Docket Item #5
BAR CASE #2004-0280
BAR Meeting
April 27, 2005

ISSUE: New residential building
APPLICANT: Anna Maria & Michael Dechert
LOCATION: 804 Pendleton Street
ZONE: RB Residential

UPDATE: The applicant has revised the plans to attempt to meet the concerns expressed at the February 23, 2005 meeting. The most significant alterations address the concerns about the mass, height and scale of the house. The applicant has maintained the original concept of two blocks linked by a hyphen but has altered the footprint to create longer and narrower block at the rear. The block at the rear of the house has been pulled back from the east side property line by 3' and extends 5' further to the rear of the property. The house remains a two story house with full third story attic and raised basement, but the overall height of the house has been lowered by 1'4" and the roof form has been changed to a full mansard on all sides.

Figure 2 Proposed site plan

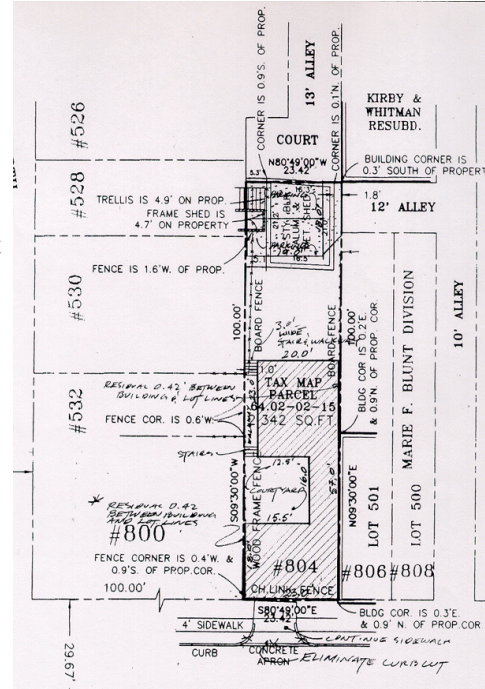
Staff notes that the plat shows numerous existing structures, including fences, a trellis and the house at 806 Pendleton Street that encroach on the property. The applicant is encouraged to discuss how each of these encroachments will be handled with the respective property owners

well in advance of construction. Staff is aware that the owner of 806 Pendleton Street and the applicant have begun discussions regarding drainage issues and how the buildings will be joined. As shown, the west wall of the proposed building will adjoin 806 Pendleton Street along its east wall. This condition is traditional throughout the densely built historic areas of Alexandria and is recommended from a maintenance standpoint.

Figure 3 Proposed north (front) elevation

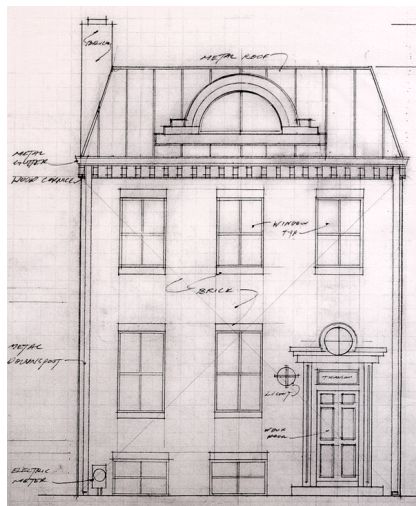
The front elevation differs from the prior submission in several respects. The overall height is 1'4" lower due to a lower third story and smaller cornice. The first story windows are shorter than in the previous iteration and thus closer in size to the second story windows. The basement windows are now at grade rather than raised slightly above with exposed sills. As mentioned above, the cornice is smaller and simpler. The roof now is a true mansard, with sloping sides, rather than the faux cornice of the previous design. Instead of three small gabled dormers there is now one large semi-circular dormer.

- The front door is now shown as a six panel and a four panel. Staff believes a four panel door is more appropriate to the nouveau Empire appearance of the house and works better with the surround.

- The dormer windows appear somewhat overscaled;
- Staff would prefer the use of stone, wood or cast stone lintels to the proposed soldier course sills and lintels, but will not object to their use here.

Figure 5 Proposed west elevation

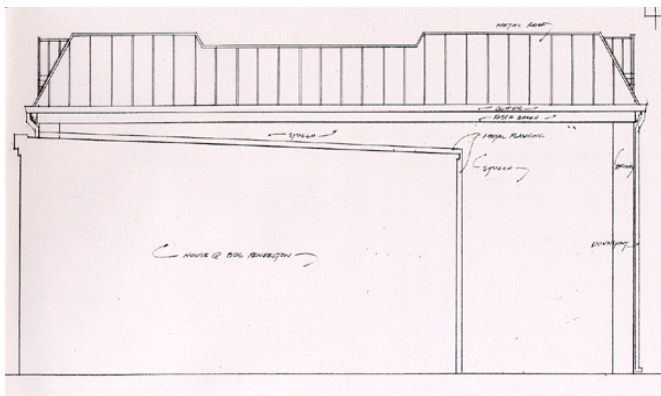
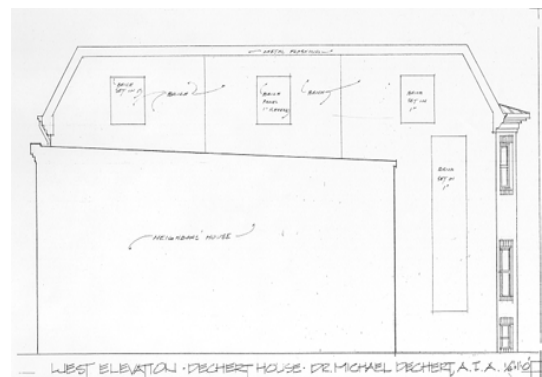
This elevation is now 1' 4" lower and 5' longer than previously. It is no longer entirely brick, but mostly stucco with a strip of brick at either end. The inset panels have been eliminated. The roofline now consists of three mansard forms rather than a flat topped brick wall.

Material Similarly, Staff is of two minds about the change in the material of the east and west walls from brick to stucco. Staff assumes this alteration was in response to suggestions that a lighter material might help to reduce the perception of mass and that the use of brick trim on these elevations was to help in breaking up the mass. In general Staff does not like to see stucco and brick used in combination as it has a false appearance and is a convention more commonly seen in suburban construction. The applicant apparently is unwilling to consider using wood (or Hardiplank) to lighten the appearance, as was previously suggested. Alternatively, the applicant might consider using brick throughout, as in the previous submission, but painting it a lighter color. Staff recognizes that the painting previously unpainted masonry surfaces is discouraged in the historic districts (*Design Guidelines*, Paint Colors - Page 1). However, that prohibition is intended to apply more to historic buildings and to preserve red brick rows. Here, the building is new and the adjacent properties are frame or already painted masonry.

Figure 7 Proposed east elevation

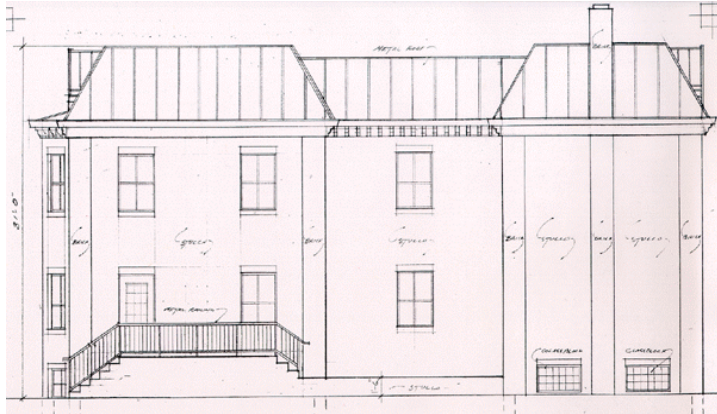
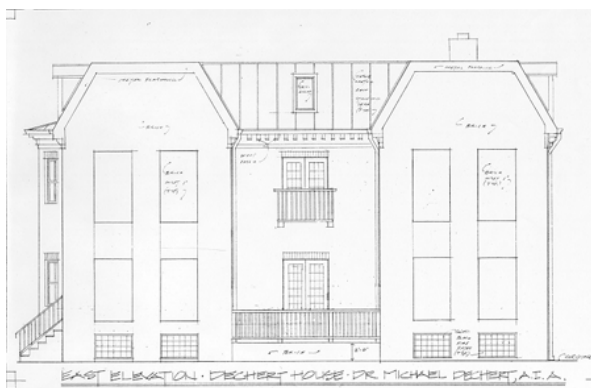
The east elevation has changed considerably from the previous design. In addition to the lowered height and the use of a full mansard for the third story, the rear block has been pushed back from the east property line by 3' and extended to the rear by 5'. As a result of the removal from the property line, the rear block can now have opening in accordance with the building code. There are now three windows and a door where there was a blank facade. The hyphen now has windows where it previously had french doors.

The patio has been lowered by 6" so that it is now 1'6" above grade. The east facing skylight on the hypen roof has been eliminated.

Mass The use of a full mansard roof throughout appears to help to reduce the perception of mass. Not only does it provide a third story which slopes away from the face of the building but it breaks up the elevation by introducing another material at the third story. The impact of this alteration is particularly visible on the west elevation. The alterations to the footprint are less easy to assess. The applicant has maintained, and actually increased by a minimal amount, the gross square footage of the building on the first and second stories while shifting the dimensions of the rear block. Rather than the original almost square block, it is now a longer, narrower form. It seems that the impacts have simply shifted along with the dimensions. Now, while the rear block no longer presses up against the east property line, it is longer on both the east and west sides by 5'.

Figure 9 Proposed south (rear) elevation

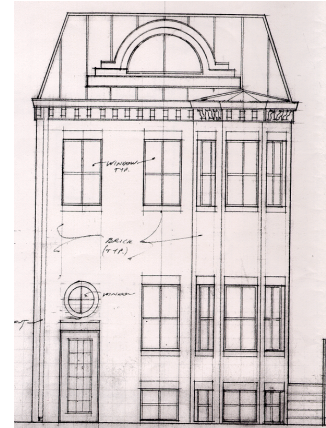
This elevation has had a number of changes. It is 3' narrower than previously as it is set back from the east property line by 3'. The bay has shifted to the far right (east) side of the elevation. The fenestration changes include the elimination of the rear door exiting from the kitchen (now shifted to the east elevation), and of the french doors on the first story. The door to the basement level is now the only door. The two gabled dormers have been replaced by the single large dormer. The areaway for the HVAC units that was located at the base of the facade has been eliminated. The HVAC units are now located beneath the stoop on the east side.

Figure 11 Proposed streetscape

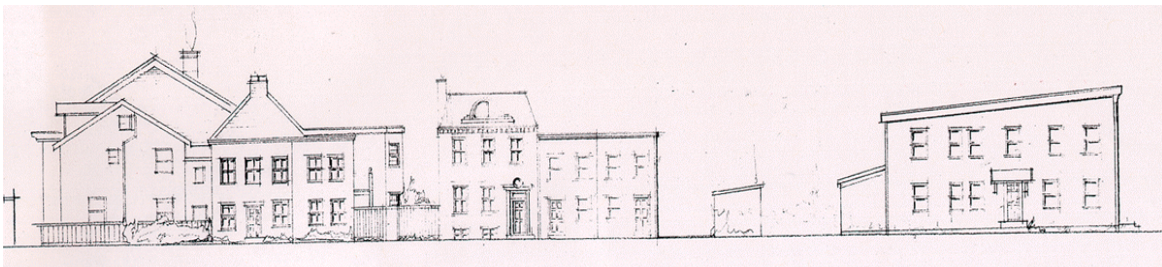
While the revised design is an improvement over the previous design, Staff feels that more work is needed to ensure that the new building is compatible with the scale of the neighborhood. Specific aspects of the revised design are addressed in more detail below:

Height The height is lower, but only by 1'4". This reduction is helpful but not sufficient to bring the building into scale with the neighboring properties. As discussed in the previous Staff report, the immediately adjacent properties at 802, 806 and 808 Pendelton Street, which create the setting for the proposed building, are diminutive even by Parker-Gray standards. All are built on the ground with no foundation visible. None of the buildings are likely to be much over 20' in height. Similarly, the houses around the corner on the east side of the 500 block of Alfred Street are exceptionally narrow and not particularly tall.. Staff would like to see a more substantial reduction in height. One past recommendation that deserves consideration is stepping the building down toward the rear. This is the traditional pattern for the historic districts. If no further reductions can be made in the height of the third story, the applicant should eliminate or substantially reduce the exposed basement and use light wells instead.
